Development Facilitation Team (DFT) – Review Comments

DRB Project No: PR-2020-003484 Date: 10/11/2023 Agenda Item: #7 Zone Atlas Page: E-10

Application For: SD-2023-00048 – PRELIMINARY PLAT (DHO)

THE GROUP | RON HENSLEY agent for **NAFEESA PASHTOON** requests the aforementioned action(s) for all or a portion of: **LOTS 2 & 3 BLOCK 12 UNIT 3, VOLCANO CLIFFS SUBD** zoned **R1-D** located on **MOJAVE ST NW between UNSER BLVD and TESUQUE DR** containing approximately **4.25** acre(s). **(E-10)** [Deferred from 4/12/23, 4/26/23b, 5/10/23b, 5/24/23b, 6/14/23, 6/28/23, 8/23/23]

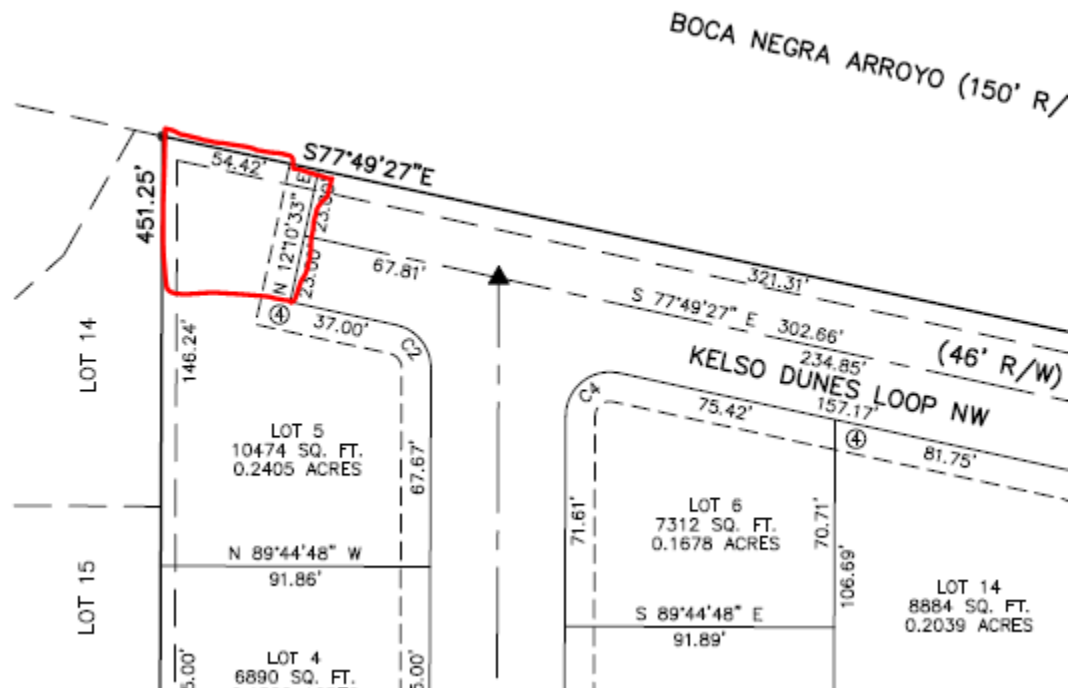
Updated 6.23.23 Change the maintenance note of Tract A (pond) to be the Homeowner's Association, not just 'owner'; city maintenance is not provided for Tract A. The landscape buffer in the northwest corner of the subdivision should be in a separate tract with a note as shown on the next page.

- **Updated 10.11.23** 5-2 (J)(2)(a) Lot 5 is abutting the Boca Negra arroyo. Add a note to the plat indicating that the 45 feet buffer abutting the Petroglyph National Monument must have plant approval and location per the Open Space Superintendent.
